Work Order ID 85927

Item Name: Head Rest

DESIGN <i>PH</i>	DRAWN BY <i>PH</i>	DART AEROSPACE LTD HAWKESBURY, ONTARIO, CANADA	
CHECKED <i>PH</i>	APPROVED <i>PH</i>	DRAWING NO. D3303	REV. B SHEET 1 OF 4
DATE 06.08.17		TITLE HEAD REST	SCALE 1:3
REV A	DATE 04.08.18	DESCRIPTION NEW ISSUE	
B	06.08.17	UPDATED FLAT PATTERN TO FORM PART IN ONE OPERATION USING OFFSET DIE

DRAWING NO. D3303	TITLE HEAD REST	REV. B	DART AEROSPACE LTD ENGINEERING ORDER		D.E.O. NO. D3303-B-1	SHEET NO. SHEET 1 OF 1	SCALE NTS
DRAWN AJS	CHECKED 1	MFG. APPR. M	APPROVED MAD		DE APPR. H		
DATE 08.10.15	DATE 08.10.15	DATE 08/10/16	DATE 08/10/16		DATE 08/10/16

**D3303-041 HEAD REST**

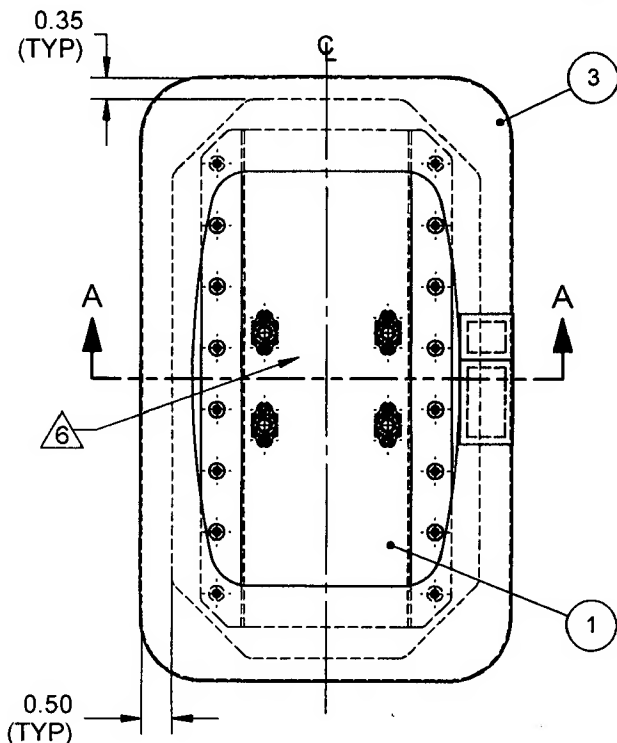
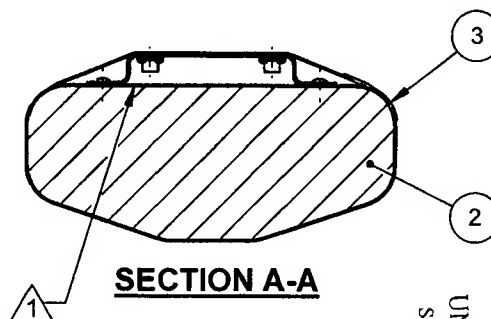
SHEET 1 ADD 1300L ADHESIVE BY 3M TO NOTE 1 AS FOLLOWS:

WAS:

NOTES:

- 1) BOND D3305-1 FOAM TO D3303-043 BRACKET ASSEMBLY USING 3M 1300 ADHESIVE (0.002" TO 0.010" THICK) IN ACCORDANCE WITH MANUFACTURER'S INSTRUCTIONS

SEE NCR 08-069 FOR FURTHER DETAILS

IS:

NOTES:

- 1) BOND D3305-1 FOAM TO D3303-043 BRACKET ASSEMBLY USING 3M 1300 OR 1300L ADHESIVE (0.002" TO 0.010" THICK) IN ACCORDANCE WITH MANUFACTURER'S INSTRUCTIONS
